# SCHWEIZER SERVICE BULLETIN

B-292  
24 Oct 2008

**SUBJECT:** MODIFICATION OF CABIN DOOR HINGES

**MODELS AFFECTED:** • 269A, TH-55A, A-1, B & C Model Helicopters, 269C Model Helicopters  
Serial No 001 through 1917

Figure B-292-1. Door Hinge Plate

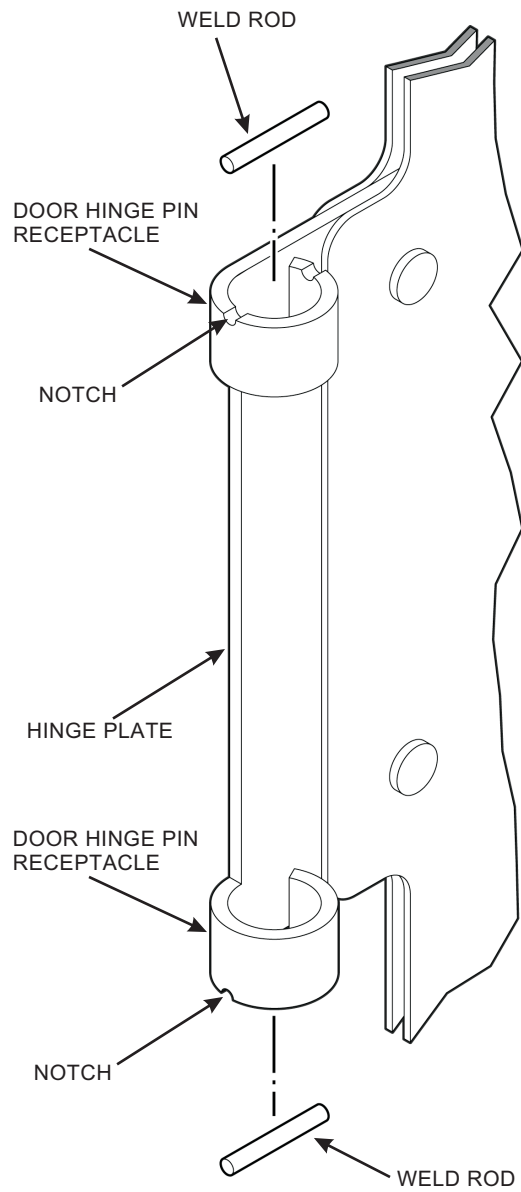
**PREFACE:** • A report has been received that a cabin door separated from a helicopter in flight as a result of the door hinge pins disengaging from the hinge assembly. The hinge pins became free when a serrated release pin came out of the hinge pin. A modification of the door hinge plate has been developed that will prevent the hinge pins from disengaging if the release pins are lost.

- c. Remove paint from two pin receptacles of both door hinges. File small notches in outside edges of pin receptacle 180° apart and centered on holes as shown in Figure B-292-1. Do not exceed one half diameter of weld rod.
- d. Place weld rod in notches with 0.0625 inch overhang on each side. Using overhang as filter, TIG weld rod to edge of hinge receptacle in accordance with Advisory Circular AC 43.13-1B, Chapter 4, Section 5. File excess material flush with outside diameter of receptacle.
- e. Restore paint finish in accordance with HMI Appendix D.
- f. As required, install doors on helicopter.

- a. As required, remove doors from helicopter.
- b. Measure the outside diameter of door hinge pin receptacle. Cut a length of stainless steel weld rod 0.125 inch longer than the diameter of the pin receptacle.

Instead of modifying the door hinge plates as directed below, the hinge plates may be replaced with a 269A4755-13 hinge half that has been reconfigured with a cap welded to the outside end of the door hinge pin receptacle.
